Super Creek Quarry Sedimentation Basins Review
By Bulot, Inc., February 2008

Subject: Super Creek Quarry Sedimentation Basins

Per your request we have reviewed Super Creek Quarry Sedimentation Basins Exhibit prepared by Webber & Webber Mining Consultants, Inc. dated February 2008.

EXHIBIT A
SUPER CREEK
QUARRY
SEDIMENTATION
BASINS
TRIBUTARY
AREAS

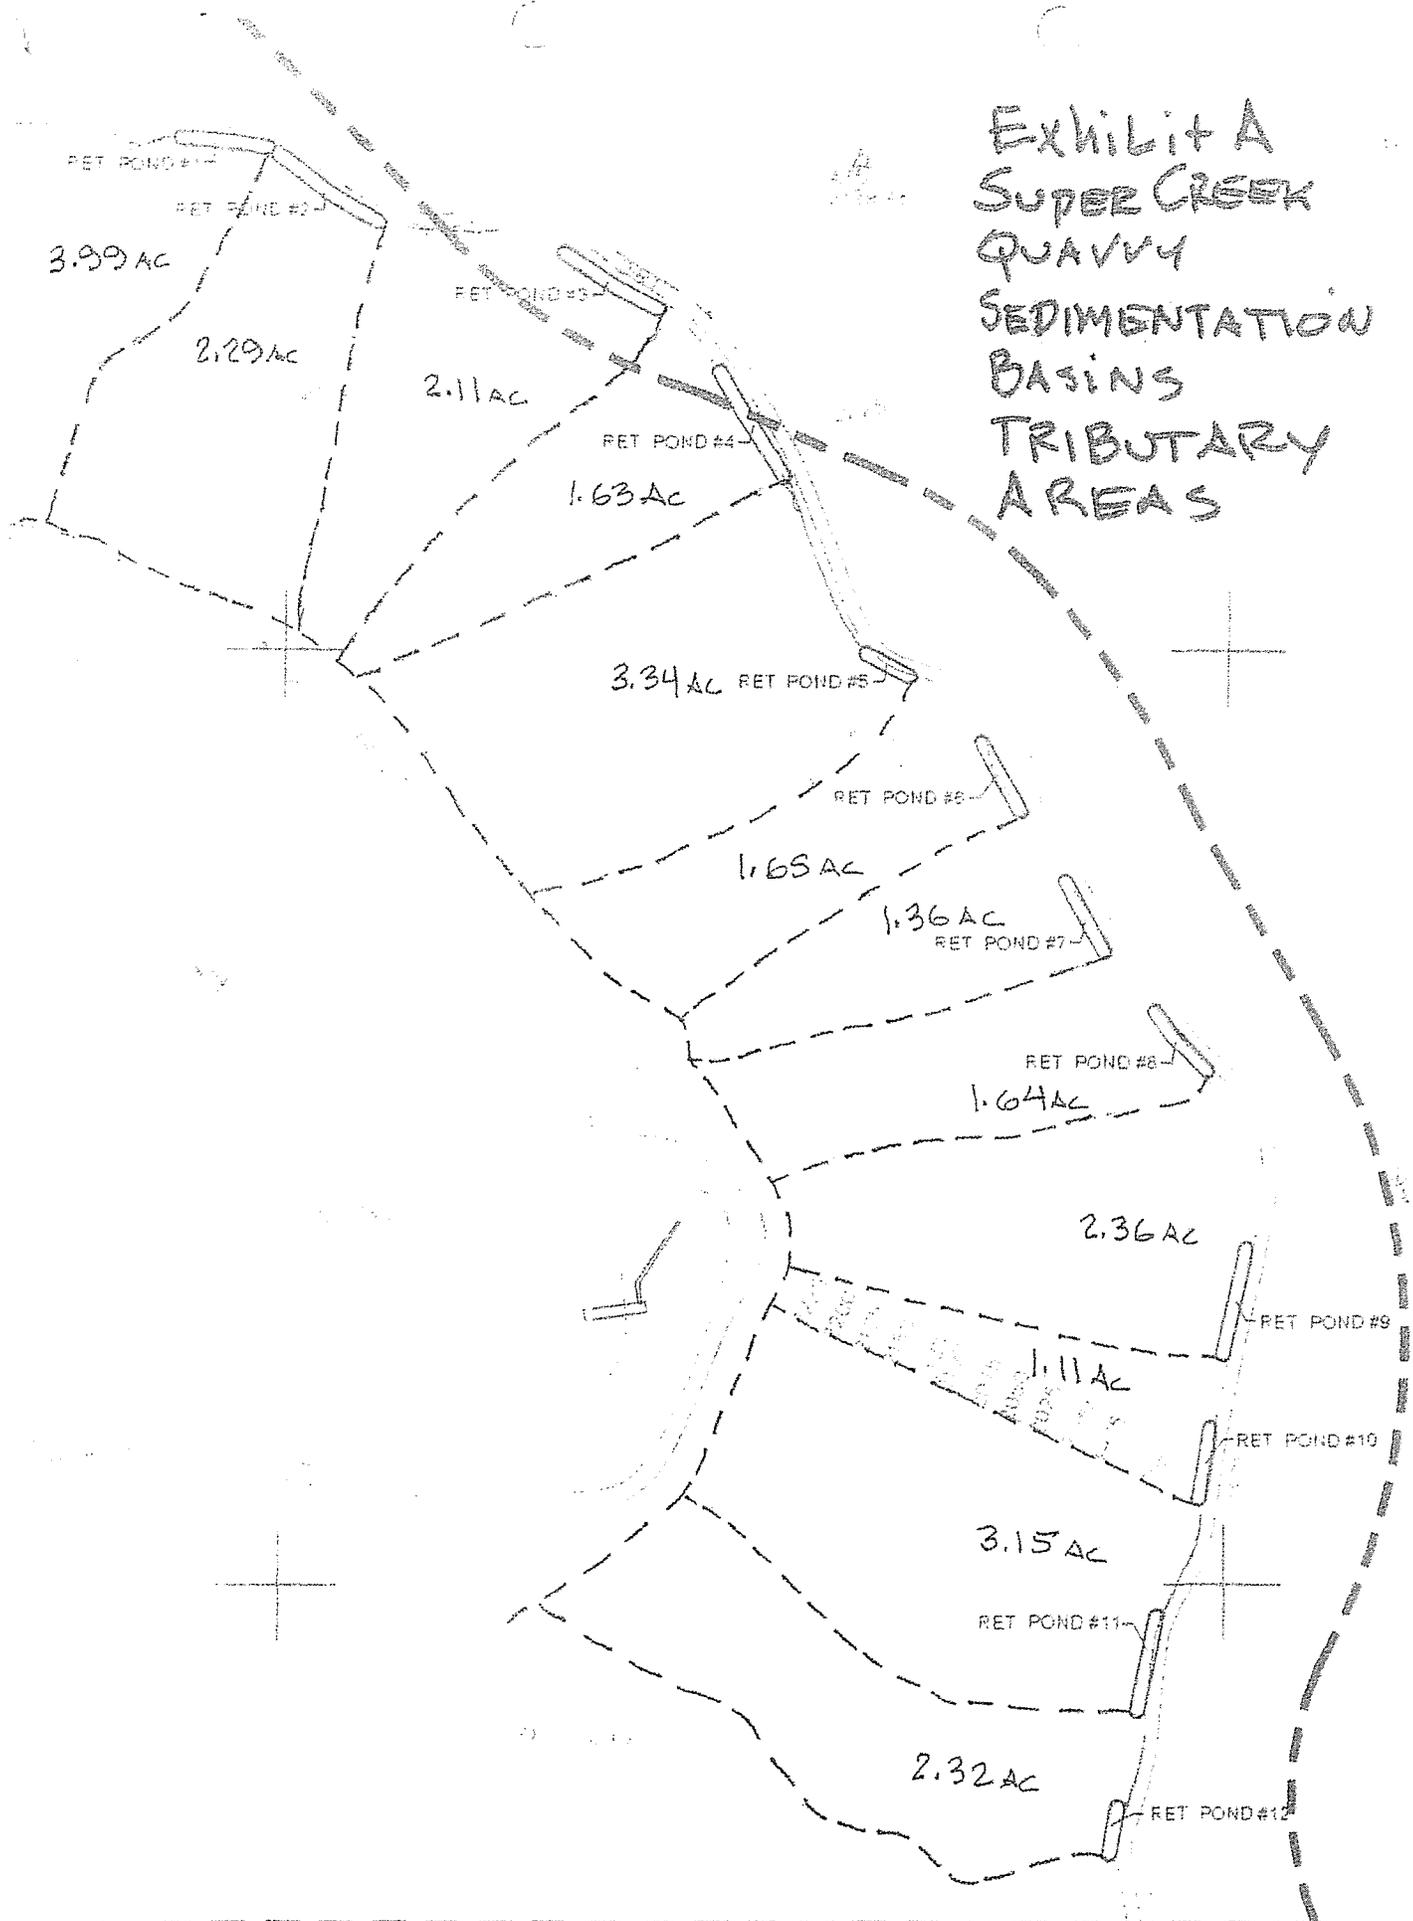
The proposed arrangement of sedimentation basins positioned as shown on the exhibit and sequentially connected by drainage ditches between provides very suitable sediment collection facilities for the present tailings slopes, both pre- and post SMARA. Should future mining operations require that the waste material slopes extend further to the northwest from Basin No. 1, this basin should be extended or a new basin upstream from this should be constructed.

The integrity and viability of these basins appears to be adequately assured by the construction of a maintenance access road for the full length of the sedimentation basin sequence (as shown on the exhibit). This road provides ready, convenient access to allow inspection and ease of maintenance. When the maintenance road is properly constructed and, as necessary, armored with rock-slope protection on the outside of the road (adjacent to Super Creek) both the road and basins are protected from the potentially eroding flows in Super Creek.

The extent of tailings slope hydraulic erosion is subject to many variables and is not easily predicted. It is recommended that at least annually, prior to the rainy season, the basins be inspected, all accumulated sediments removed and the full design volume of each basin restored. The basins should be regularly inspected throughout the rainy season and particularly after significant rain events. When a

From the topographic survey and depiction of basins as shown on the exhibit the tributary area to each basin is shown on the following table:
